Client Capital & Centric
Project Neptune Mill
Chapelton St, Manchester
Scale 1:100 @ A3
Date Jan 2023

Document External Walls
Proposed East & West Elevations
Status For information

Doc Ref 353 CD 2108 T1

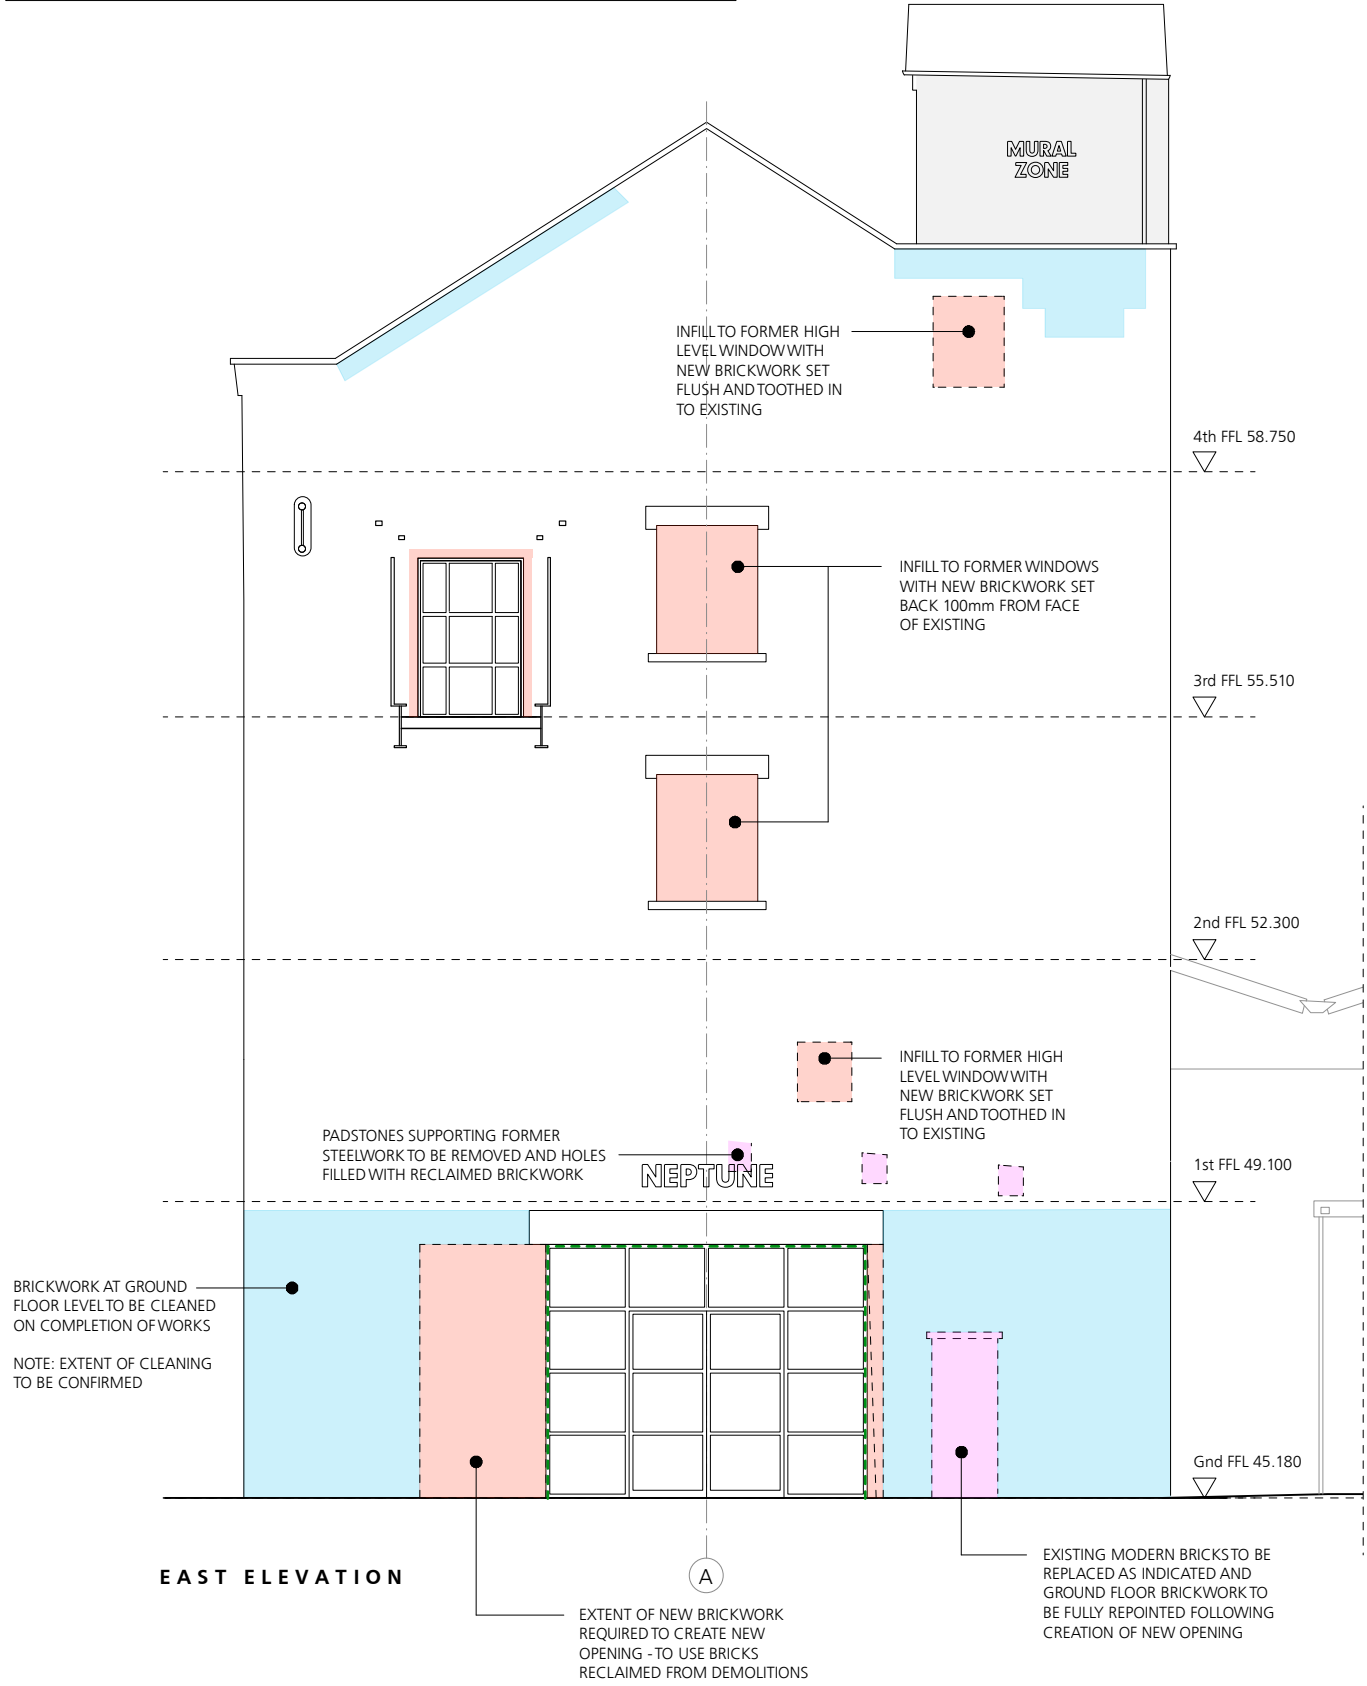
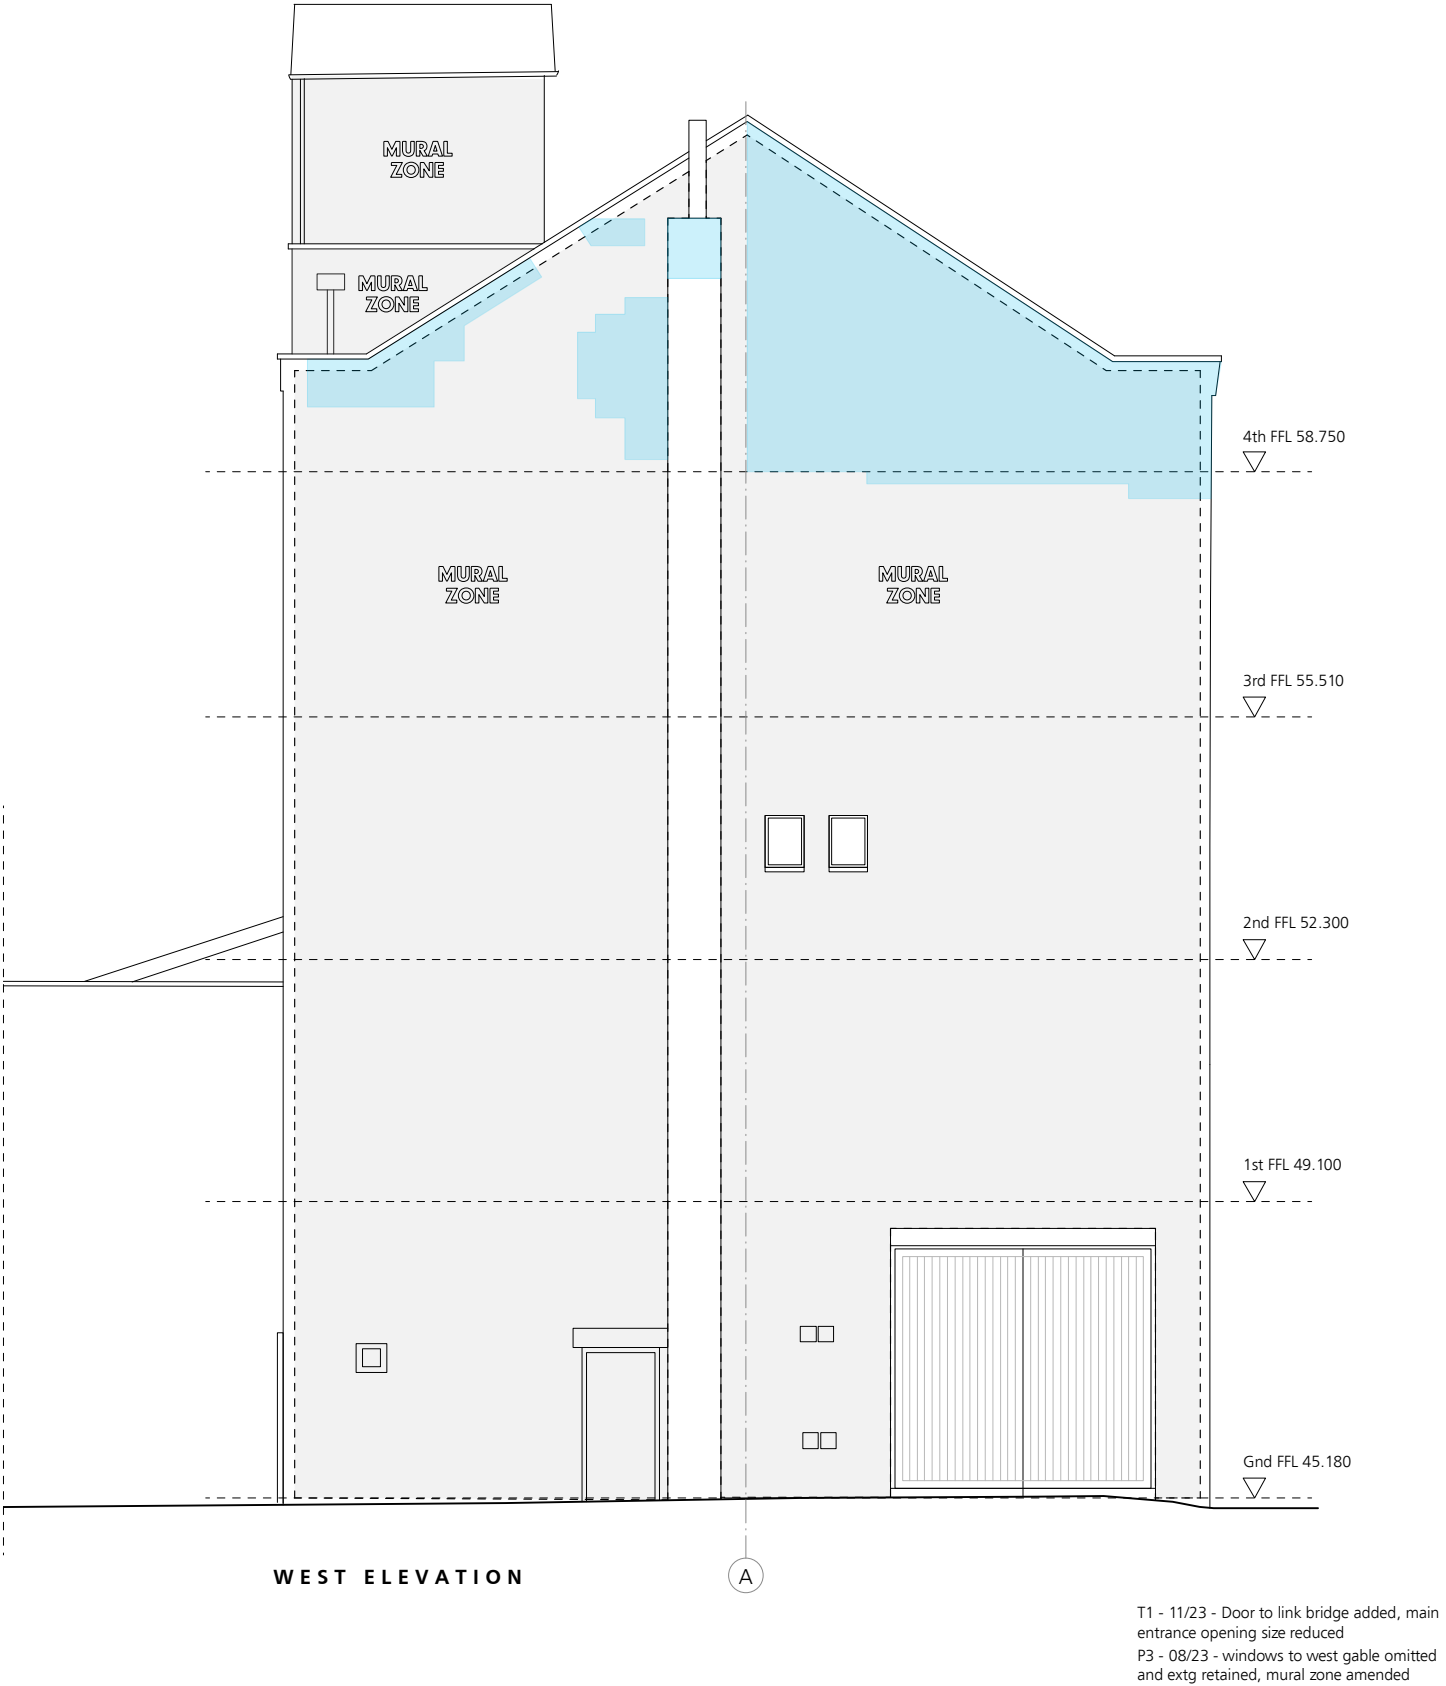
T1 - 11/23 - Door to link bridge added, main entrance opening size reduced
P3 - 08/23 - windows to west gable omitted and extg retained, mural zone amended
